AUTHORIZATION TO PROCEED WITH THE ATTENDED OPERATION OF MICROBOONE PMT TEST  
STAND AT PAB

Subject: MicroBoone PMT Test Stand

**Subject:** Electrical safety documentation required to obtain ORC approval of PMT test stand at PAB

Microboone PMT Test Stand at PAB pORC Review responses provided by T. Katori, L. Bagby.

Figure 7: HV Circuit

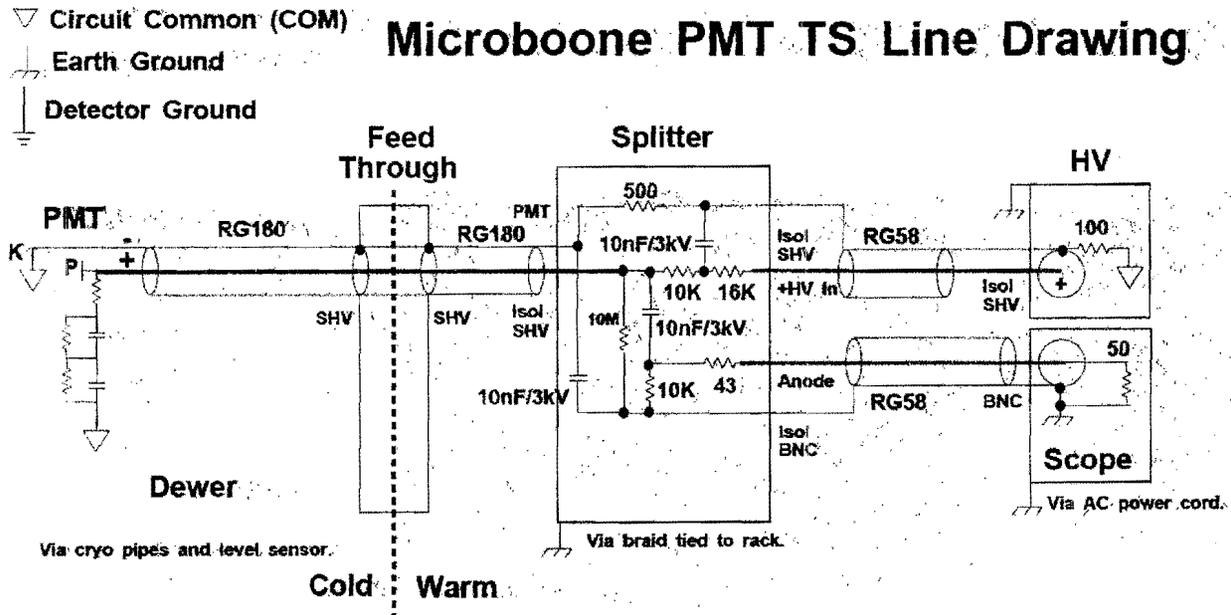
5) The grounding of the cable shields seems to be confusing. Starting with the rule (FESHM 5045-3, requirement No. 5) that the HV chassis connector shall be solidly grounded to the panel to which it is mounted, the isolating HV outputs and splitter circuit box needs to be further understood.

- 4) The HV caution labels are now placed on the four RG180 cables. –OK
- 5) The HV grounding is now understood and the custom splitter boxes, cable shield connections now match with the document supplied. Due to the operational requirements, the rule contained in FESHM 5043-3(5) is mitigated through the use of external grounding braids and the use of a “soft” grounding for the cable shields using a 500-ohm isolating resistor. Rough calculations indicate that even if all four cables were to short to the dewar vessel wall, the maximum voltage induced on the dewar metal will be about 1.5 V (3mA x 500-ohms) before the HV pods would trip on an over-current. –OK

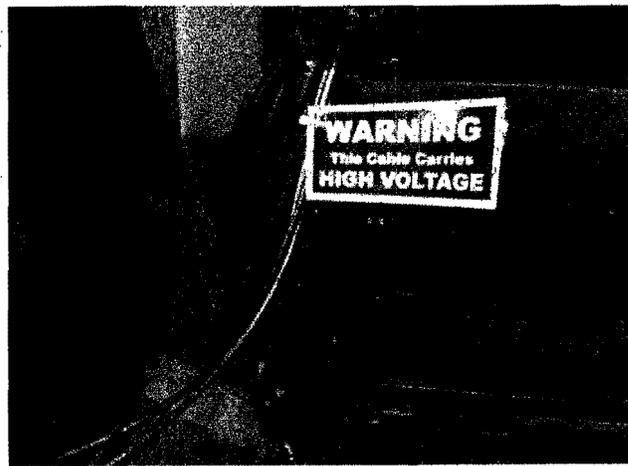
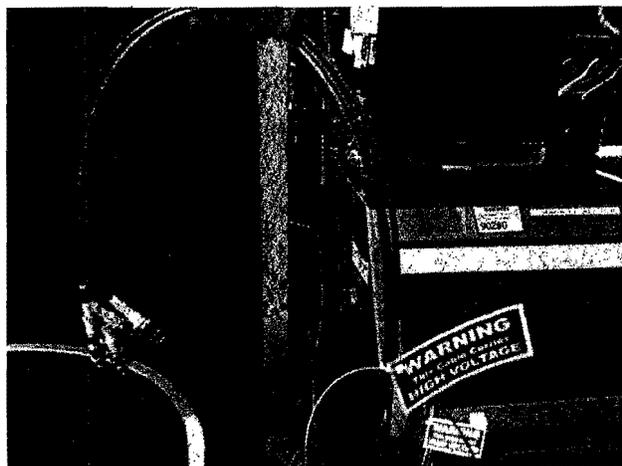
4) HV caution labels are needed for the brown RG180 cables used for the HV going into the dewar.

Response: HV Labels attached to both ends of RG180 cable.

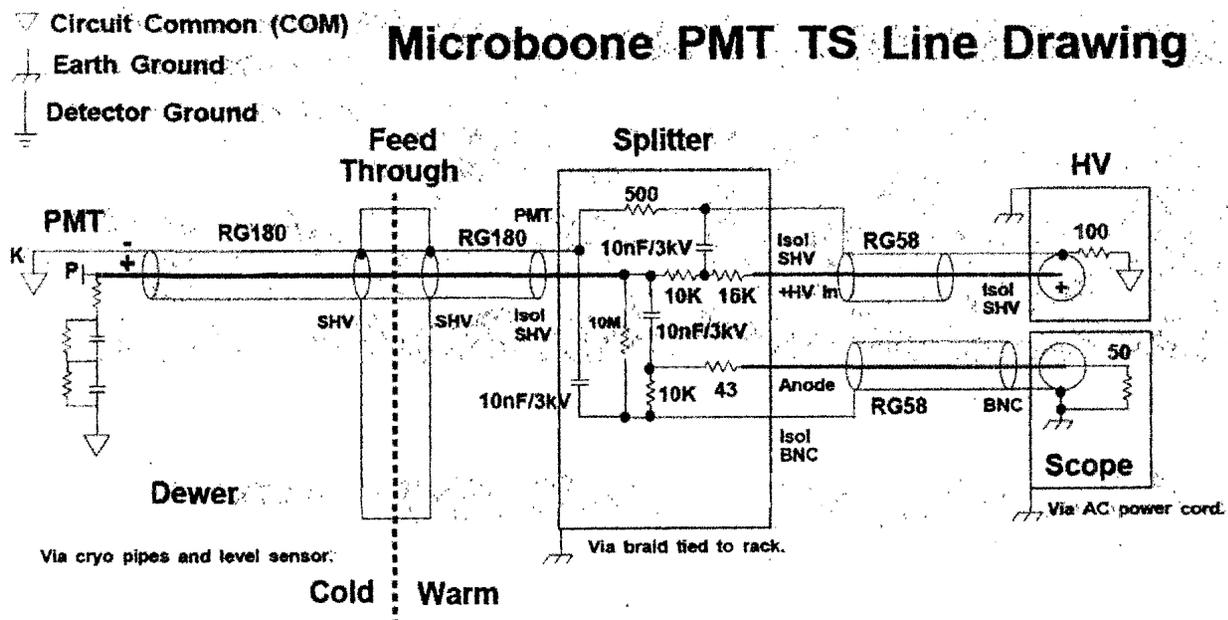
5) The grounding of the cable shields seems to be confusing. Starting with the rule FESHM 5045-3, requirement that the HV chassis connector shall be solidly grounded to the panel to which it is mounted, the isolating HV outputs and splitter circuit box needs to be further understood.

Response: Reviewed grounding scheme with Steve identifying where and how all ground connections are made in the circuit. We generated an updated schematic and added it to the Revised pORC document. Component functions of the Splitter were explained. Four identical Splitter circuits have been built per the following schematic.
